**AMENDMENT NO.13
TO THE PROFESSIONAL
ARCHITECTURAL AND
ENGINEERING (A/E) SERVICES AGREEMENT
BETWEEN THE CITY OF MIAMI BEACH,
FLORIDA AND
WOLFBERG ALVAREZ AND PARTNERS,
INC.DATED OCTOBER 26, 2022**

**FOR THE PROVISION OF ADDITIONAL PROFESSIONAL
ARCHITECTURAL AND ENGINEERING SERVICES FOR THE FLAMINGO
PARK PROJECT IN A NET CREDIT TO THE CITY IN THE AMOUNT OF
\$158,305**

SCHEDULE "A-13" - SCOPE OF SERVICES
CITY OF MIAMI BEACH
Flamingo Park Master Plan
Amendment No. 13 – June 28, 2023

RE: Flamingo Park
 WA Project No.: 28010.00
Subject: Proposal for Additional Services for Modifications to the Softball Field and Credit for Baseball Field Design Services

PLAYING FIELD PLAN
SHEET NUMBER
C-400

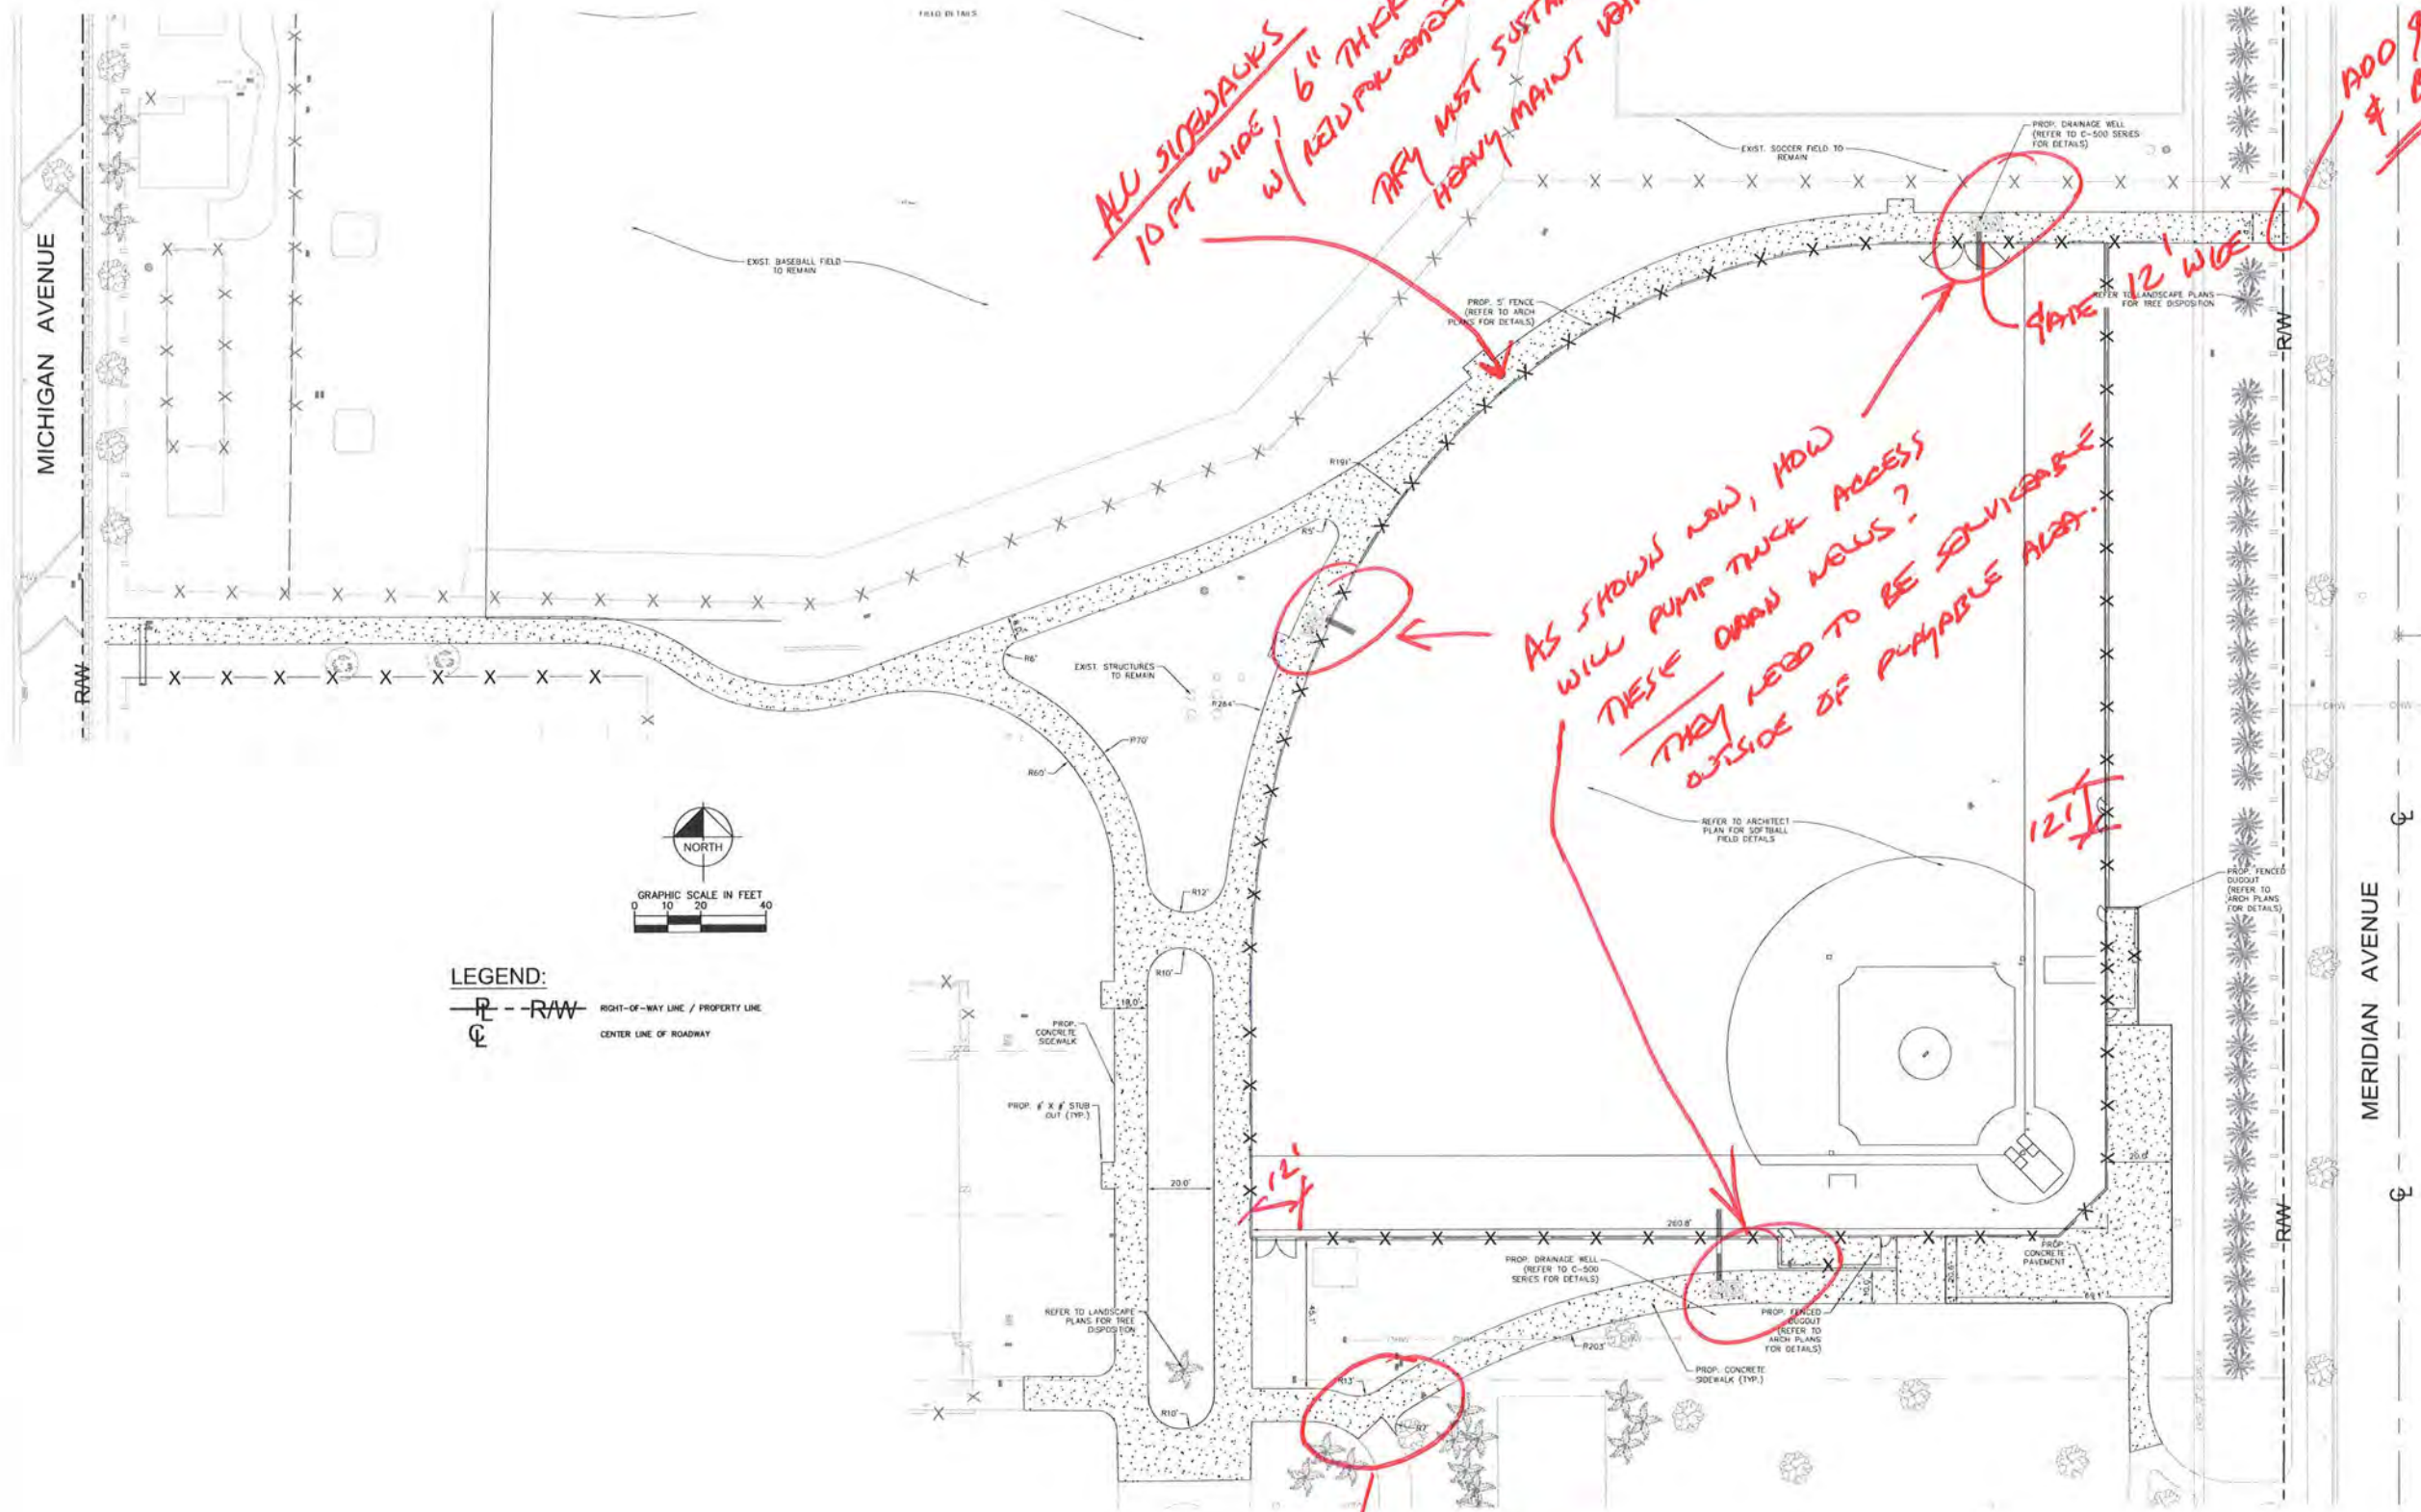
*ALL SIDEWALKS
10 FT WIDE, 6" THICK
w/ NEW CONCRETE
CURB MUST SUSTAIN
HEAVY MAINT VEHICLES!*

*AS SHOWN NOW, HOW
WILL PUMP TRUCK ACCESS
THESE DRAIN WELLS?
THEY NEED TO BE SERVICEABLE
OUTSIDE OF PUMPABLE AREA.*

*ADD GATE
& BOLLARDS*

*ARROW FOR
PUMP TRUCK
TURNING POINT*

LANDSCAPE PLAN
 SHEET NUMBER
 L-101

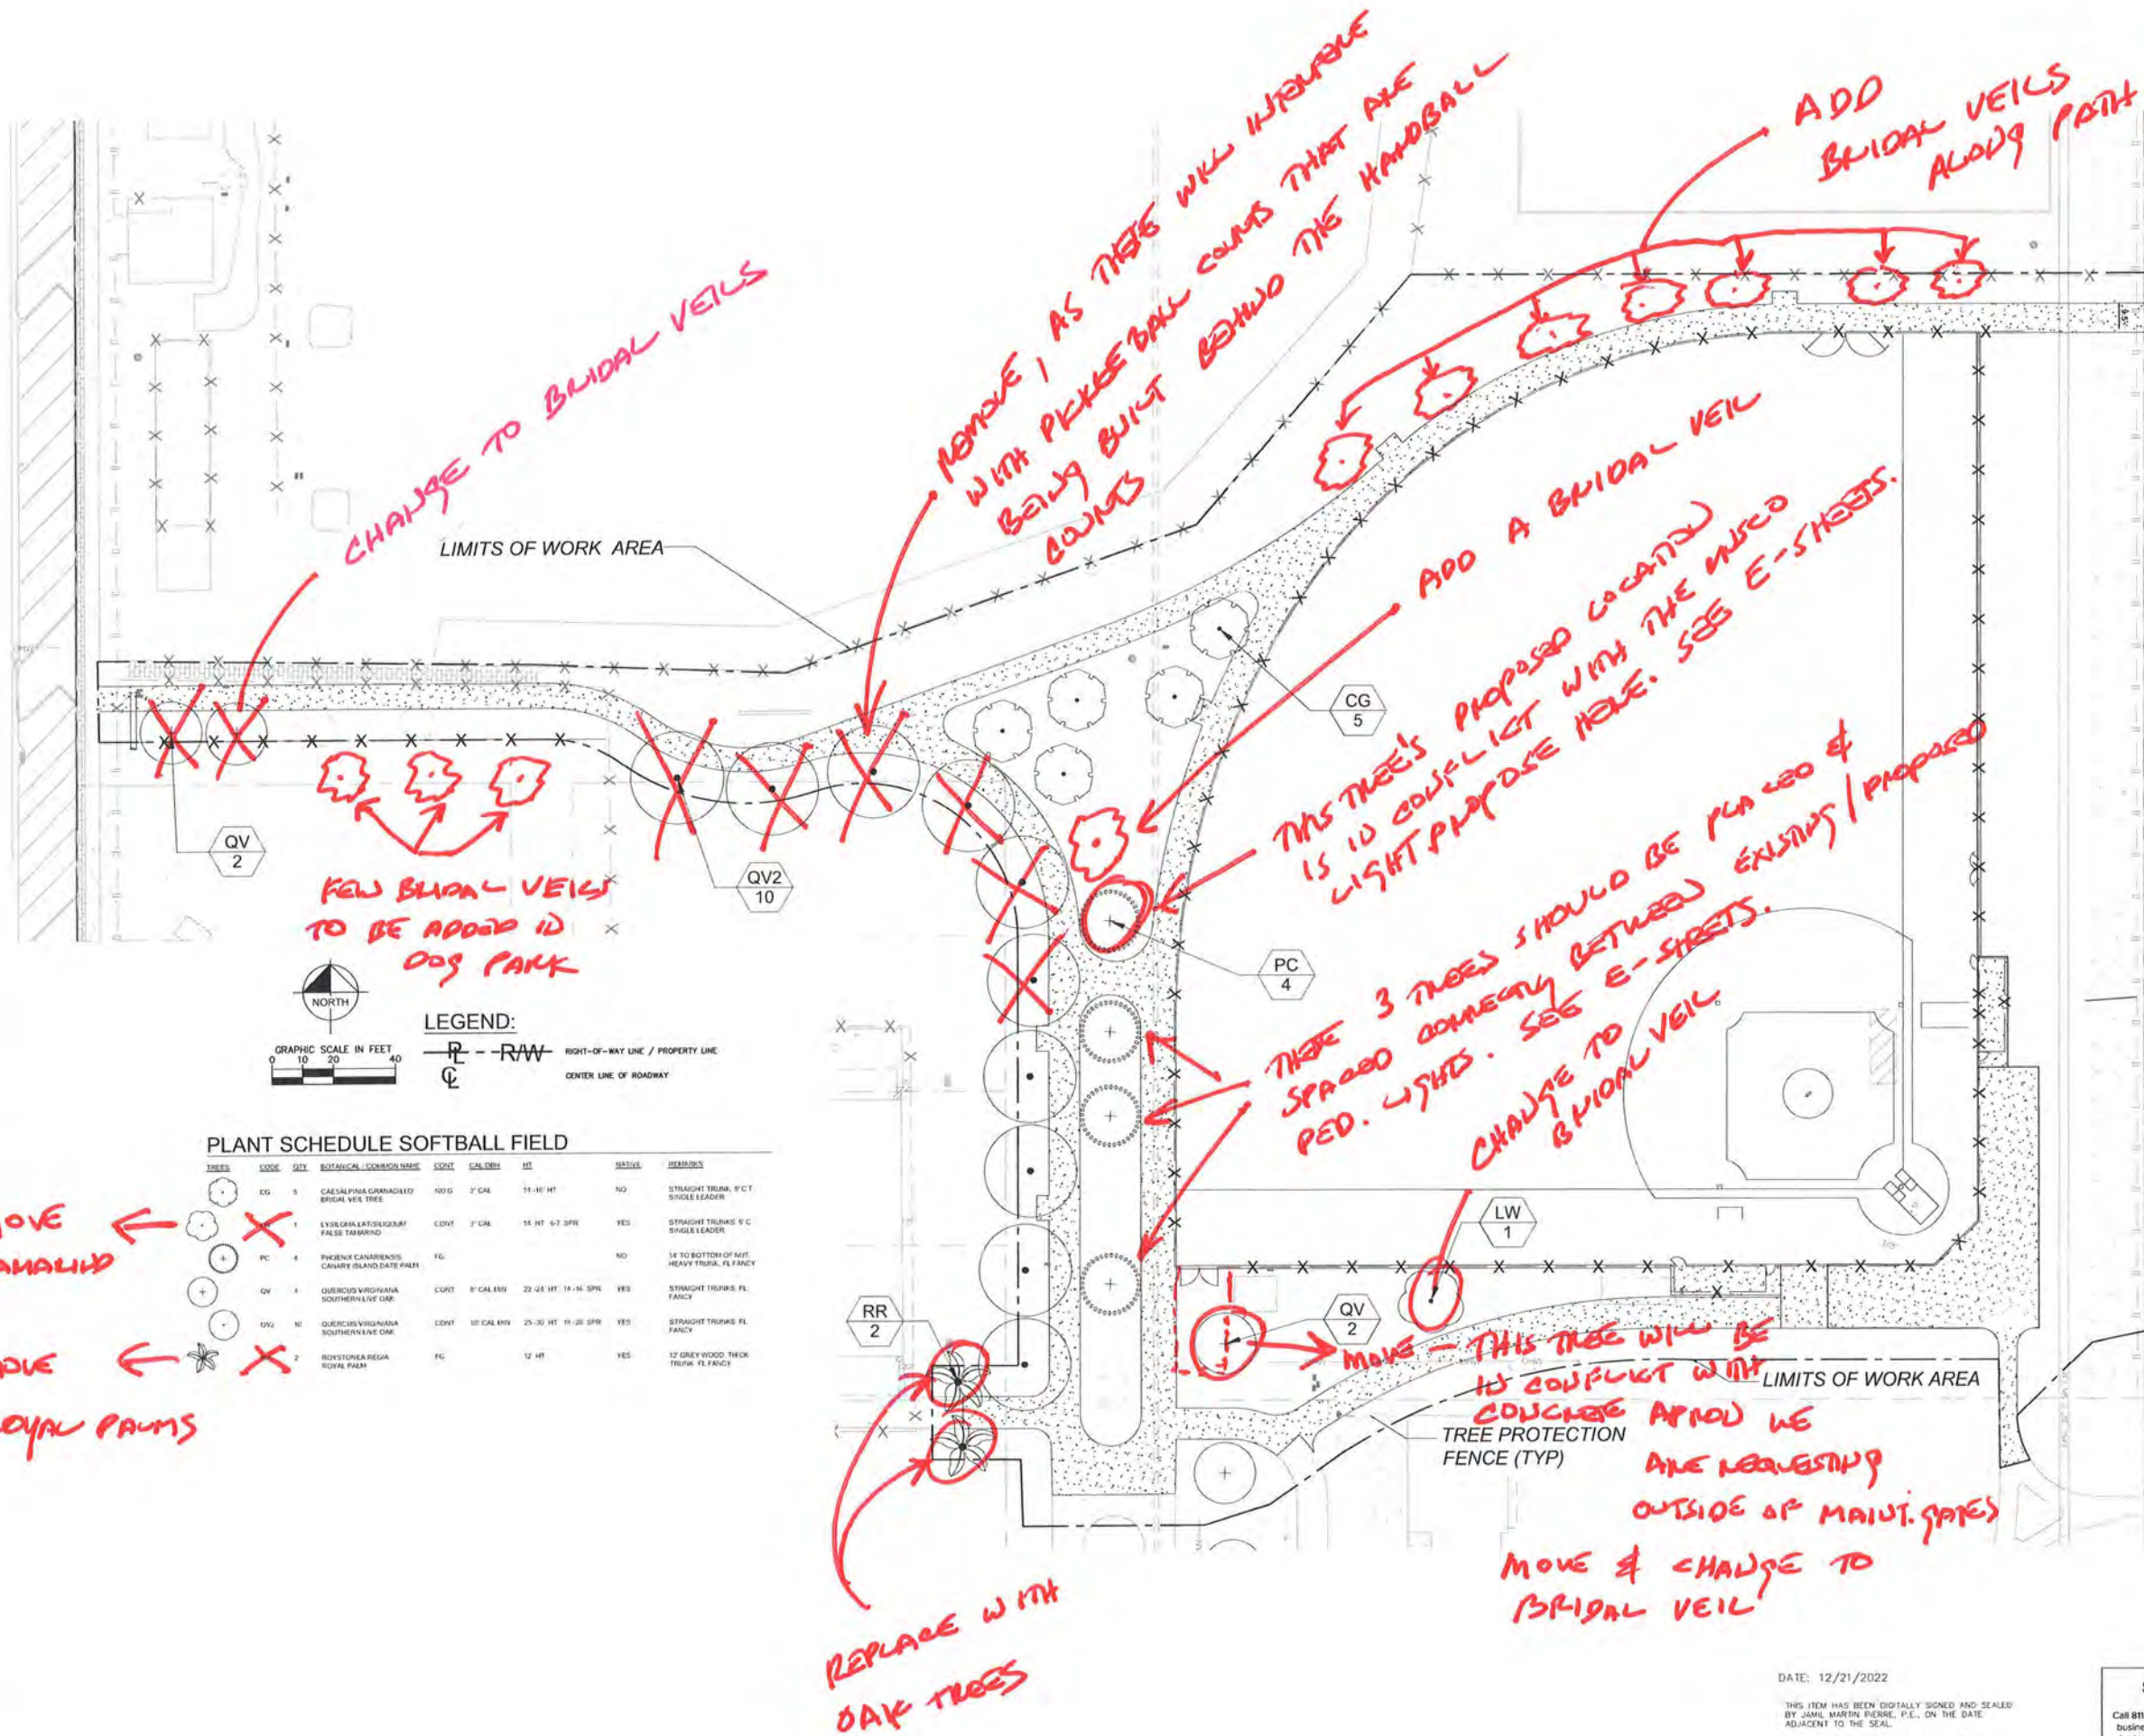
REMOVE ← NO TAMALIND
 REMOVE ← NO ROYAL PALMS

3. Modifications to landscape plans as shown on marked-up dragging L-101 attached.
4. Chain-link fencing in outfield and past backstop length to be 10ft high. Current scope calls for 6ft-8ft high chain link fencing.

DETAILS
SHEET NUMBER
A8.01

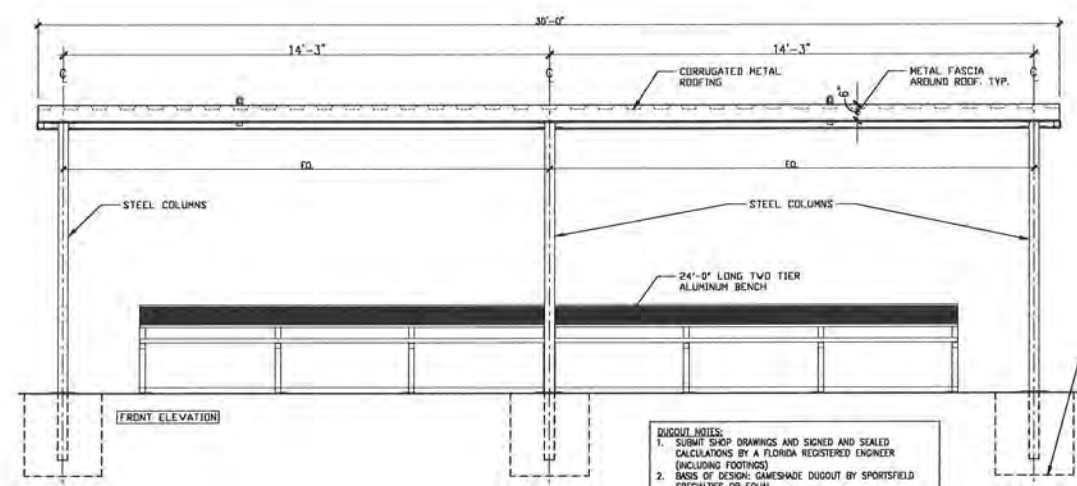
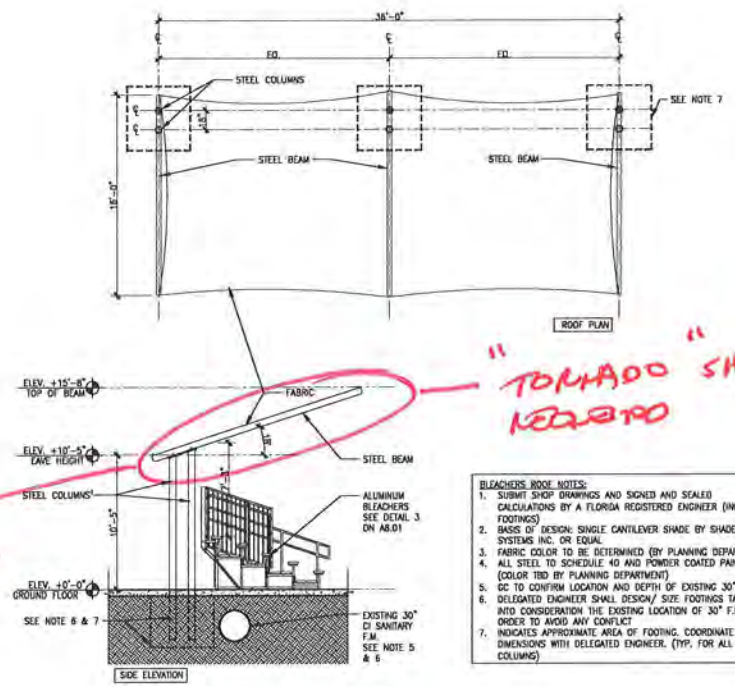
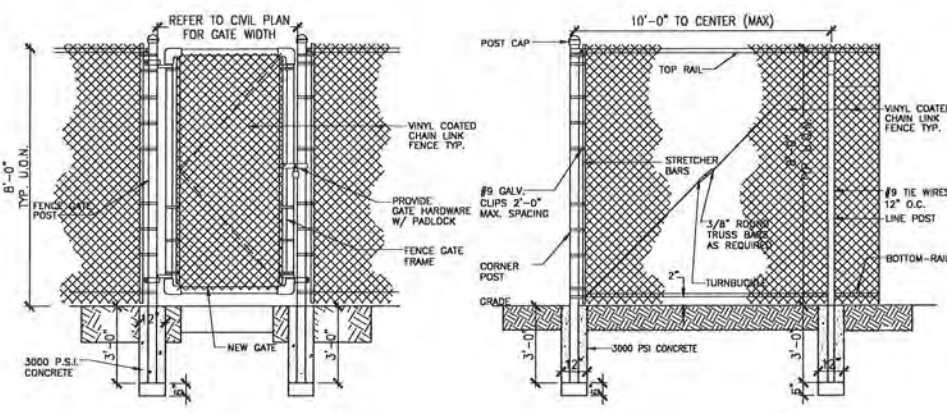
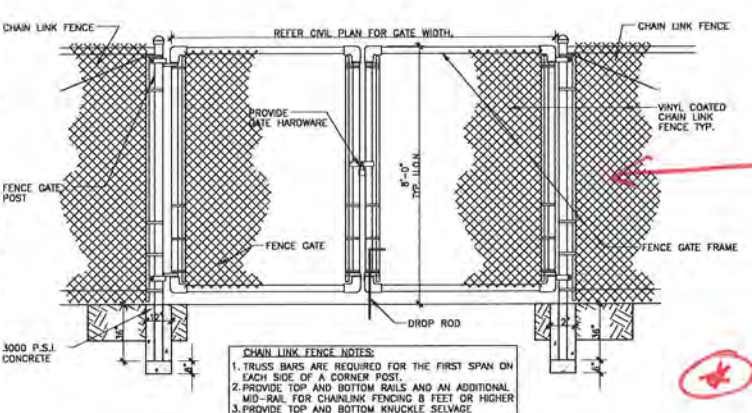
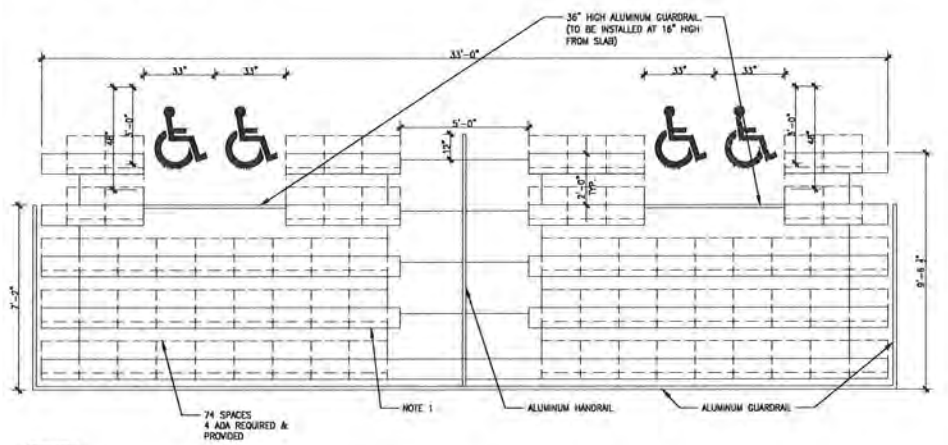
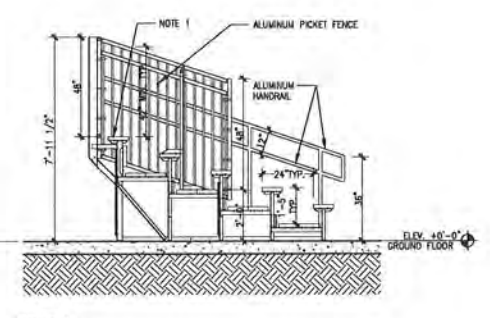
NO COLOR TO BE BLACK

VISIT SHADE SYSTEMS SITE FOR EXAMPLE

ALL FENCING BLACK VINYL COATED: MATCH GAUGE & GAUGE SIZE OF BASEBALL FENCE

YELLOW FENCE TOPPER AT TOP OF FENCE. SEE PICTURE PROVIDED IN EMAIL

FENCE SHOULD HAVE SOME TYPE OF ANTI-BULGE MECHANISM.
